FILE No. TP/99/0733

TOWN AND COUNTRY PLANNING ACT 1990
PLANNING (LISTED BUILDING AND CONSERVATION AREAS) ACT 1990
APPEALS BY ST JAMES HOMES LIMITED
SITE AT FORMER THAMES WATER RESERVOIR AND WATER TOWER HOUSE,
CAMPDEN HILL ROAD, KENSINGTON, LONDON, W8

**STATEMENT UNDER RULE 6 OF THE TOWN AND COUNTRY PLANNING
(INQUIRIES PROCEDURE) RULES 1992**

**PROOF OF EVIDENCE OF
CHARLES SCOTT**

Fig. 11. Campden Hill Square area, showing the land owned by the Lloyd family in 1820 and its later sub-divisions. Based on the Ordnance Survey of 1894-6

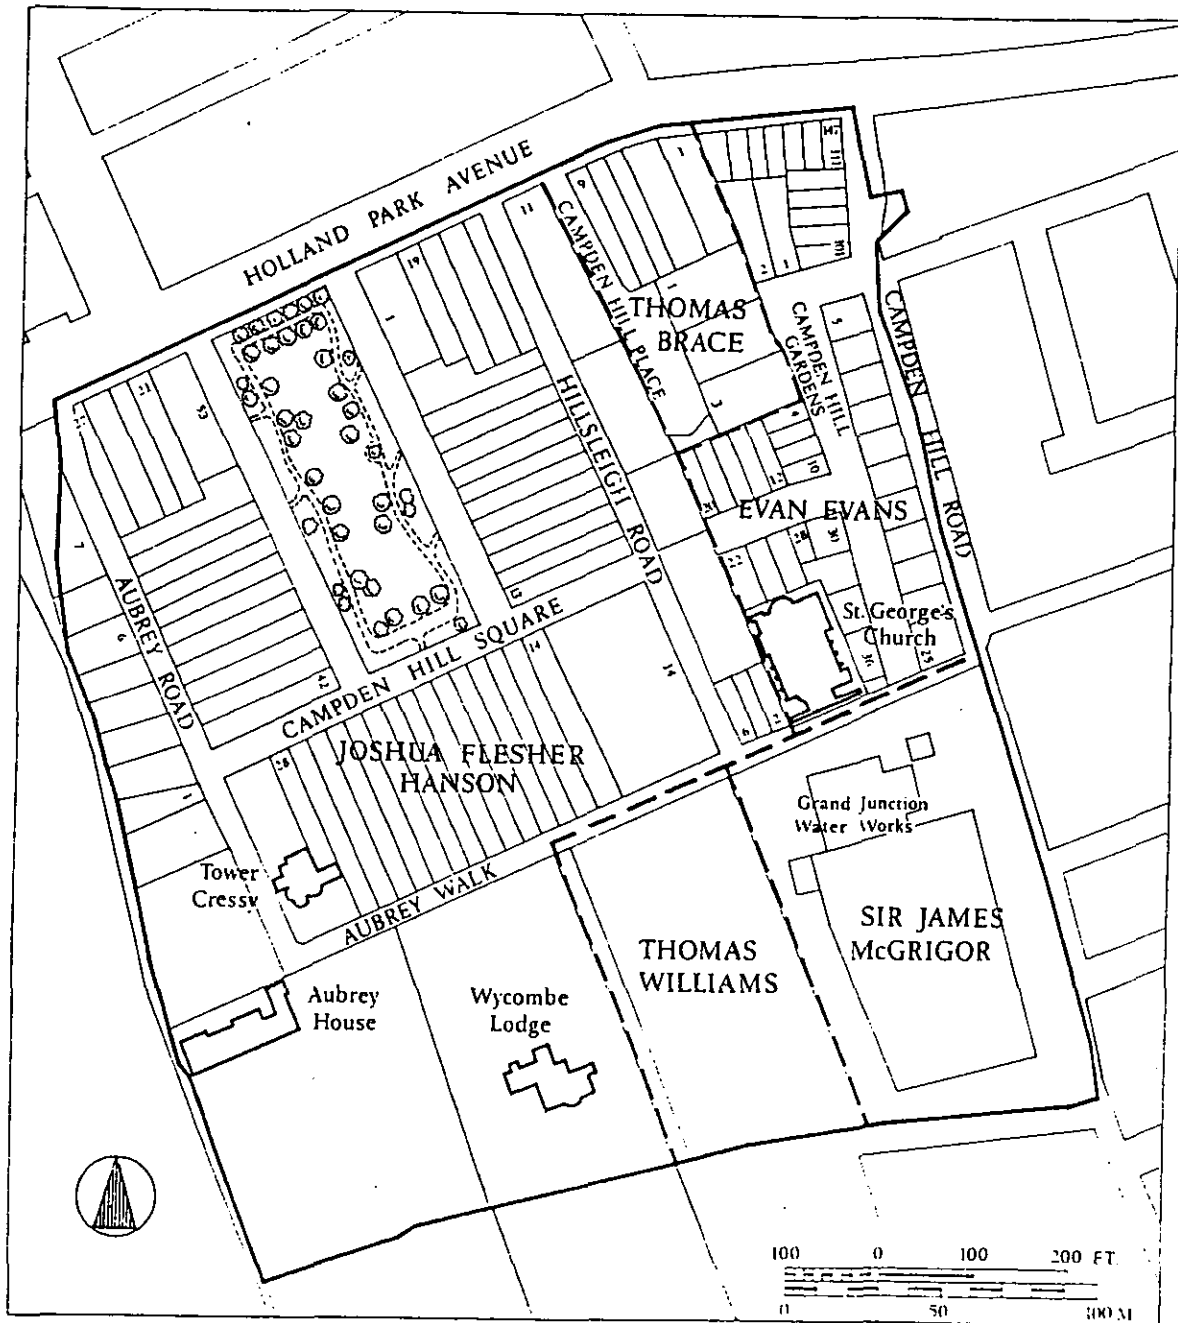
It is appropriate to recall that all seven original early 19th century houses stood in spacious grounds (as shown on attached Survey of London extract: appendix A and B) and we know that land to the north of Thorpe Lodge was purchased by the first leaseholder in 1820 (p44 JT appendices and attached S O L plan).
